# RHA - NOTES FROM THE FIELD

## CIVIL AND SITE COORDINATION

## PLUMBING DRAIN COORDINATION

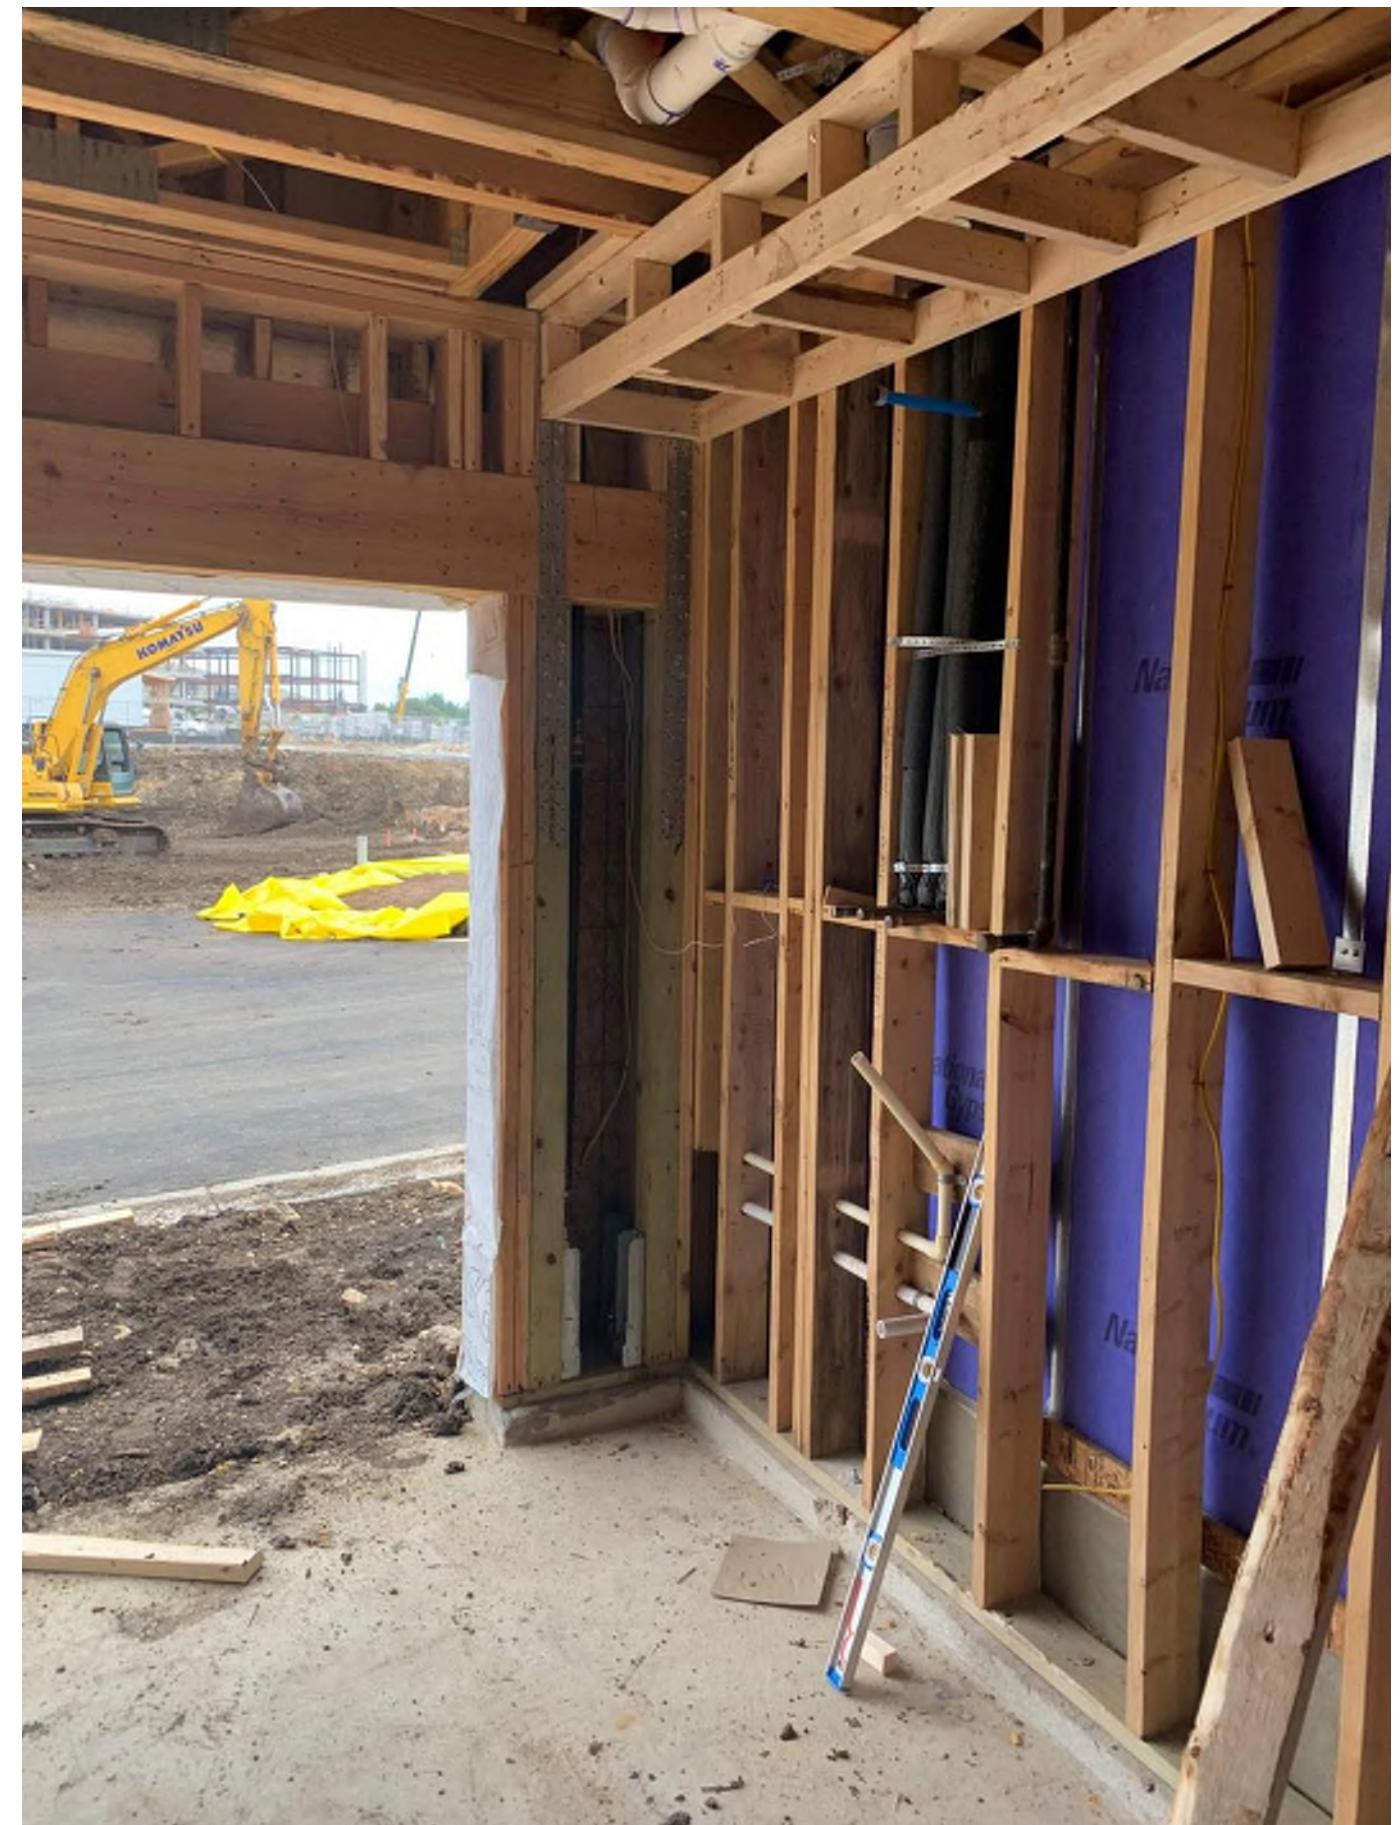
TAKE-AWAY: Coordinate all deck drains with structural and plumbing drawings

## STRUCTURAL STEEL COORDINATION

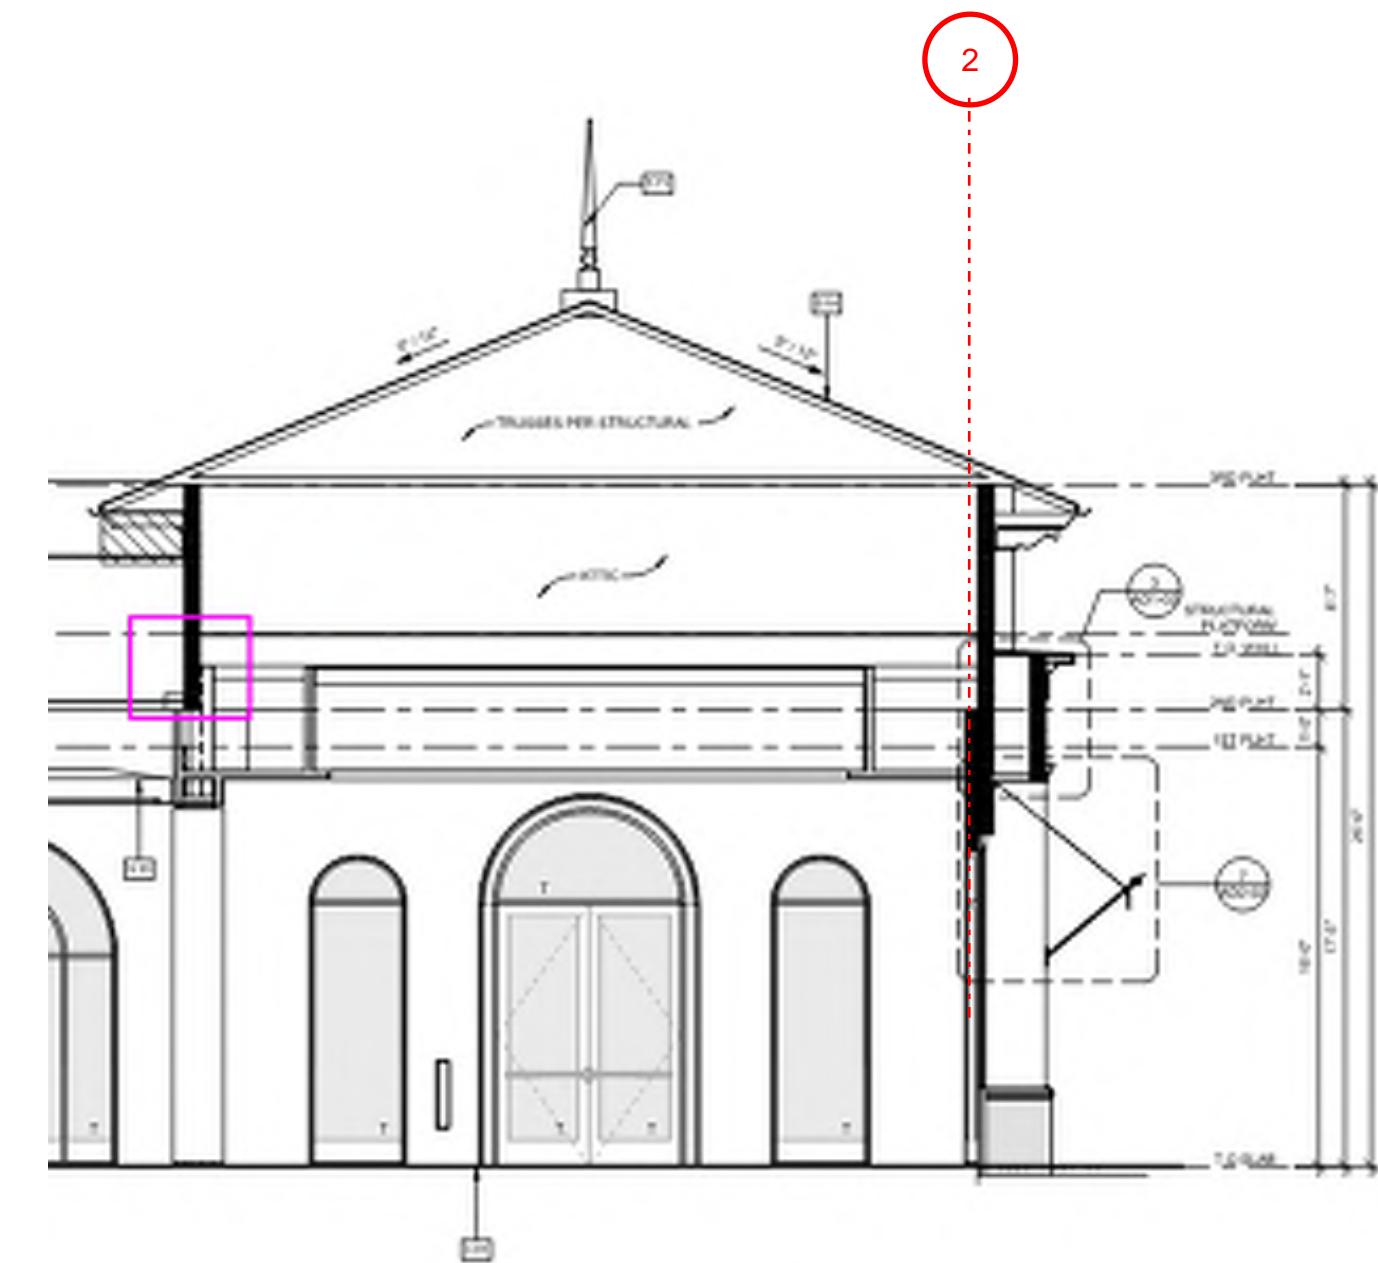
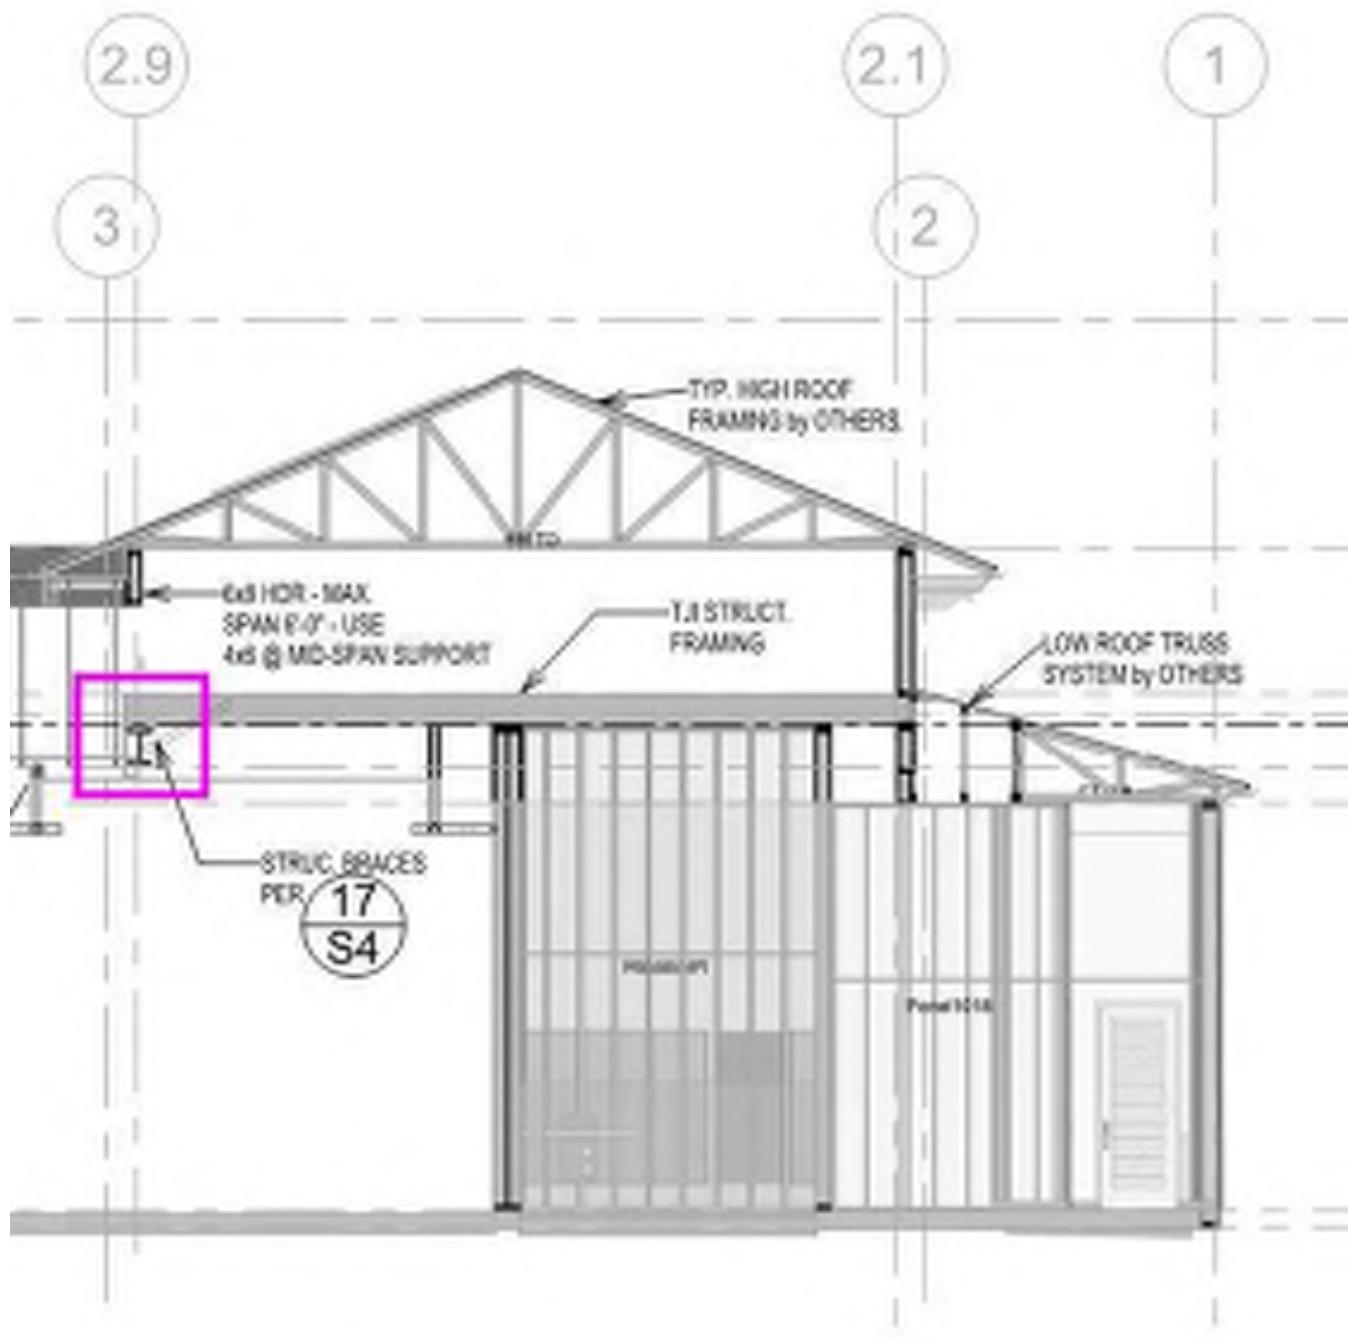
TAKE-AWAY: Show structural steel shapes in applicable plans and sections  
Show Grid Lines in sections

## STRUCTURAL STEEL COORDINATION

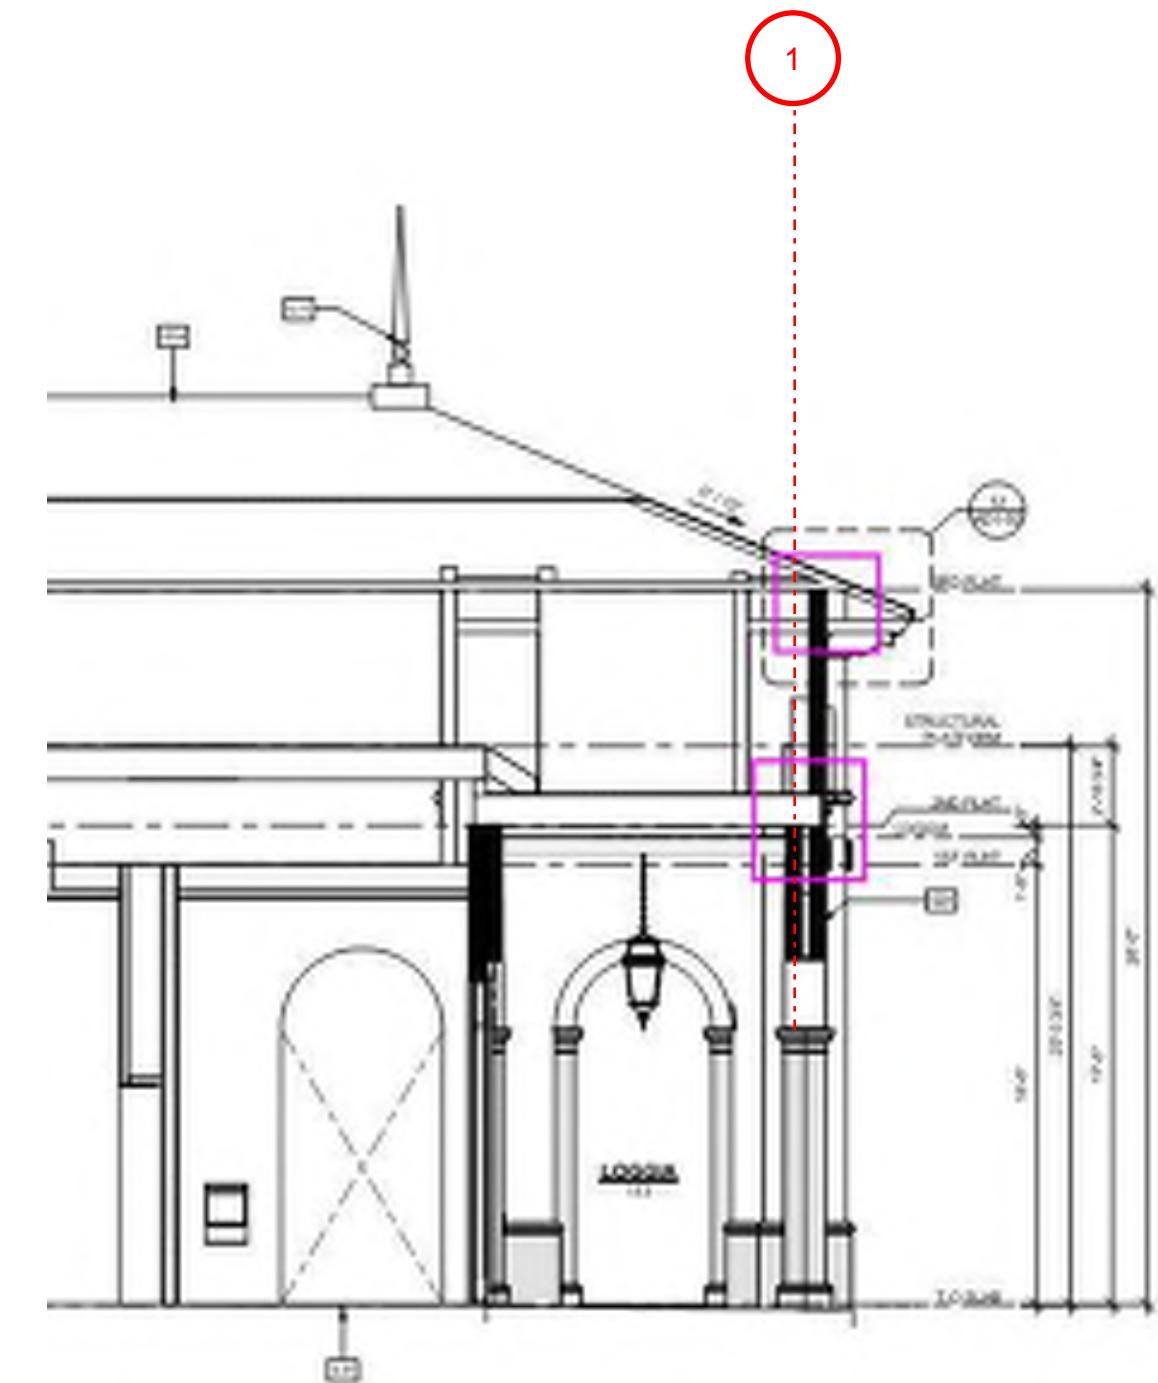
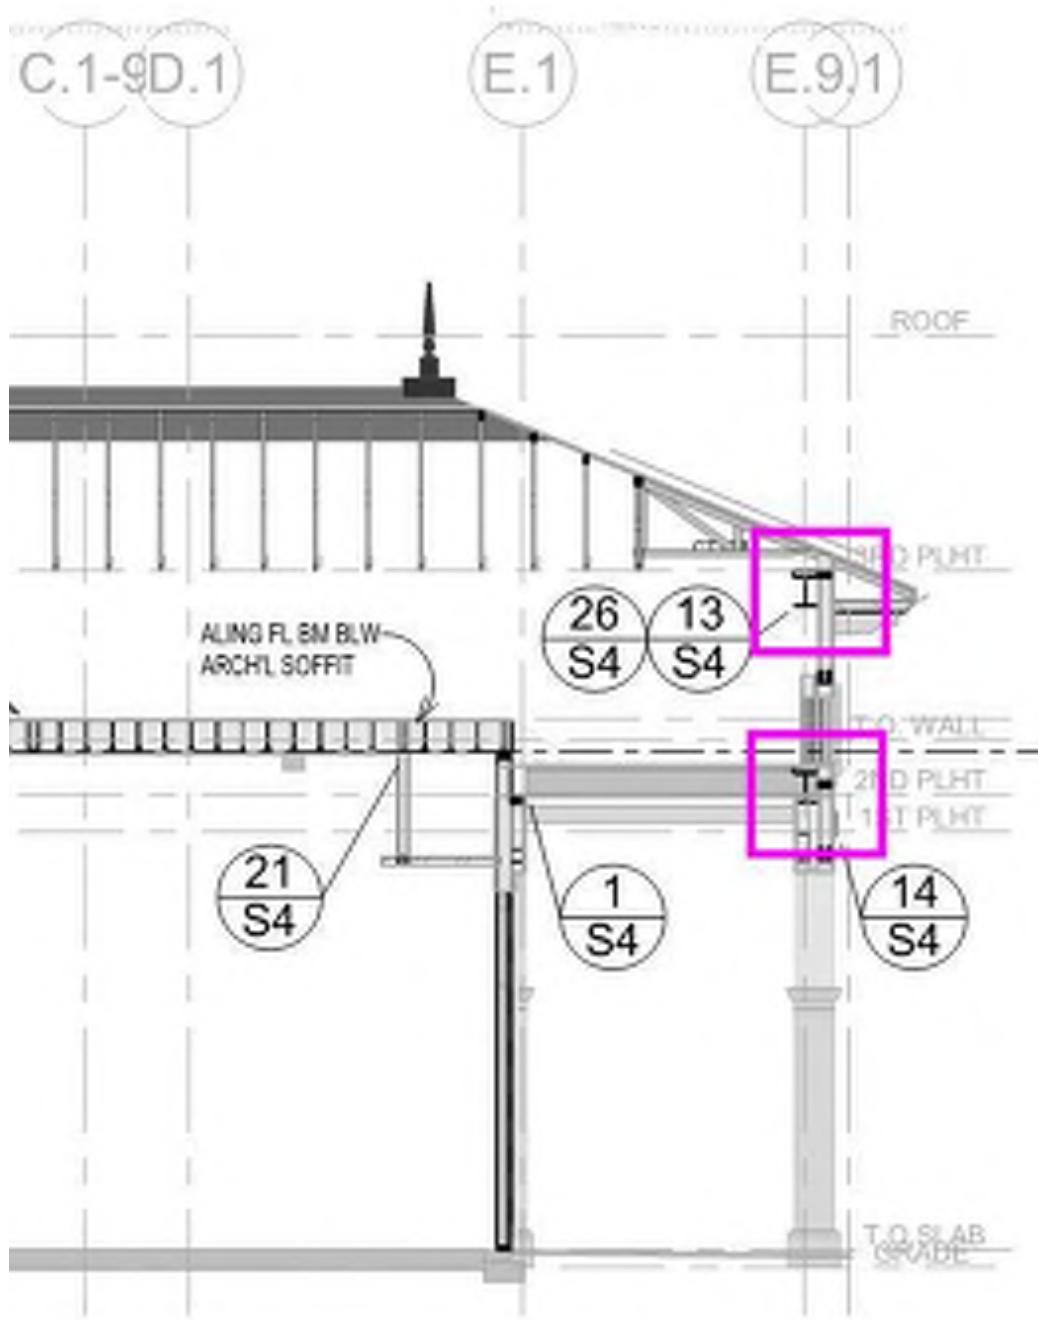
TAKE-AWAY: Show structural steel shapes in applicable plans and sections  
Show Grid Lines in sections

## HVAC COORDINATION

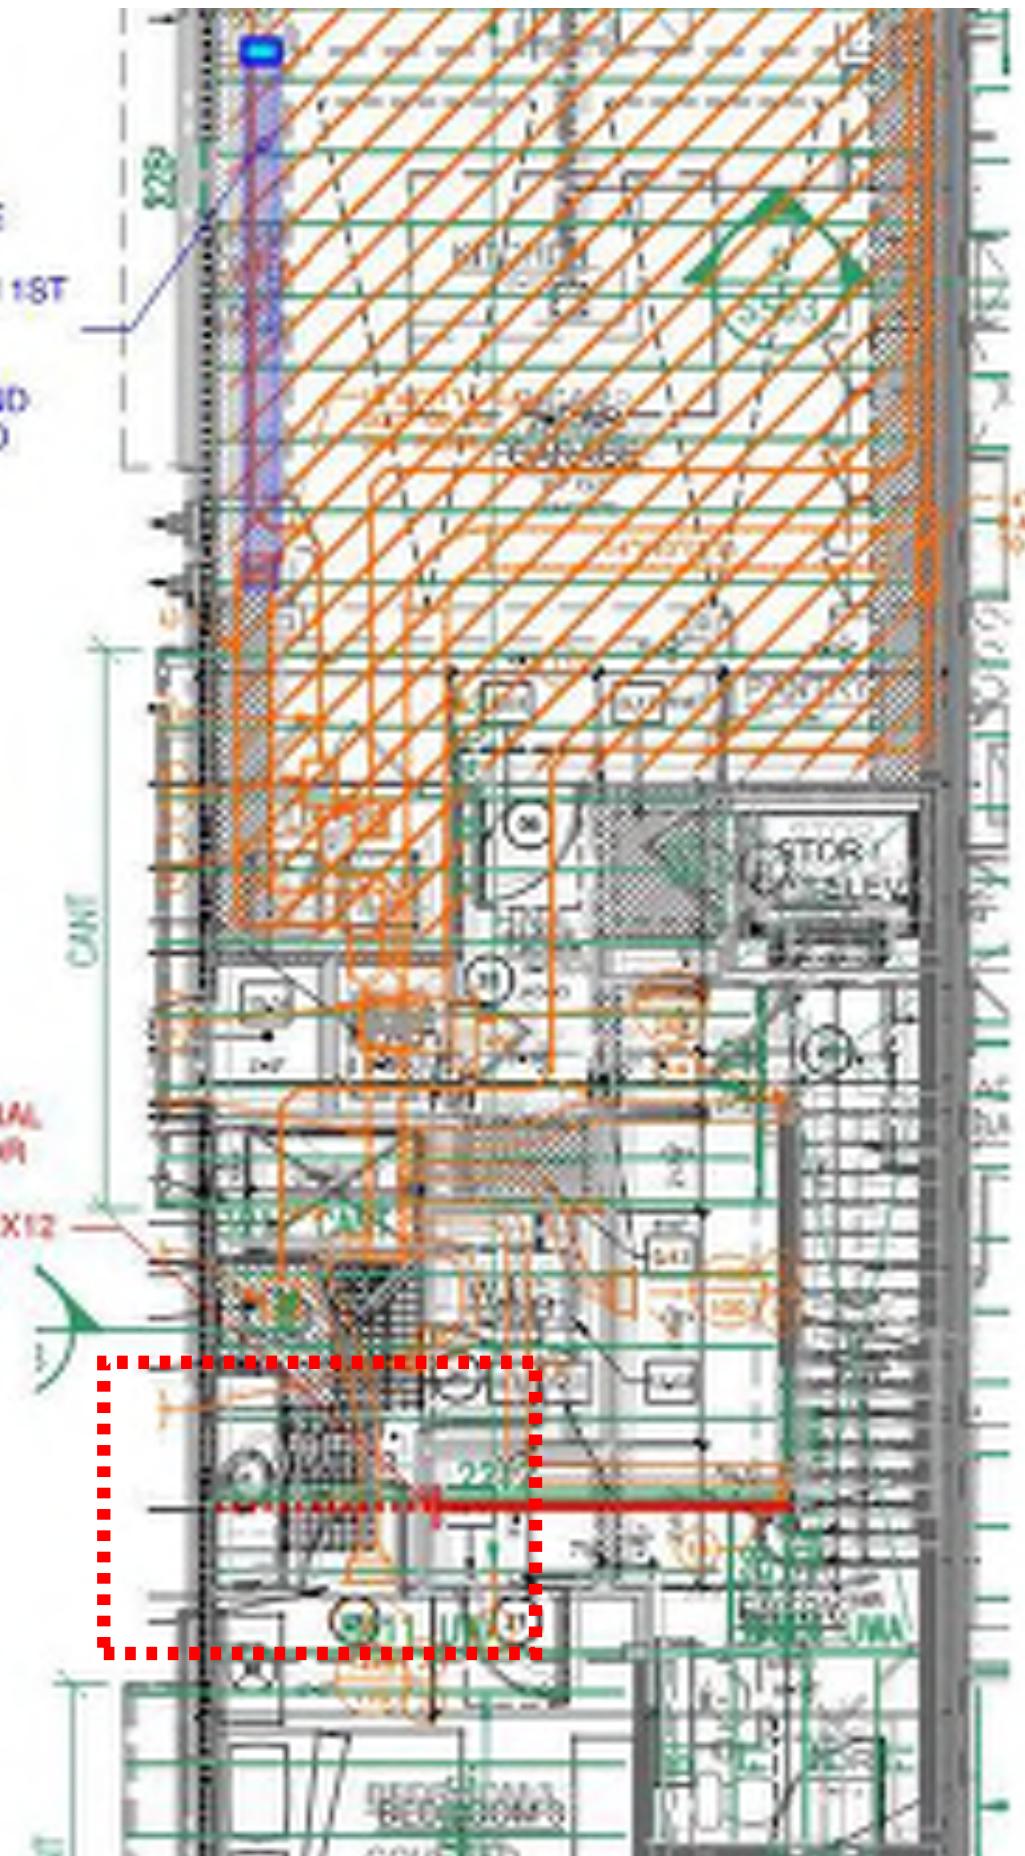
TAKE-AWAY: It is the architects responsibility to coordinate Mechanical and Structural Consultants. - Particularly when they are contracted under RHA

HVAC -  
CONTINUE  
DUCT  
THROUGH 1ST  
FLOOR  
GARAGE  
SOFFIT AND  
UP TO 2ND  
FLOOR

STRUCTURAL  
- 1ST FLOOR  
SHORTEN  
SOLID (2) 2X12  
TO ALLOW  
FOR HVAC  
DUCT
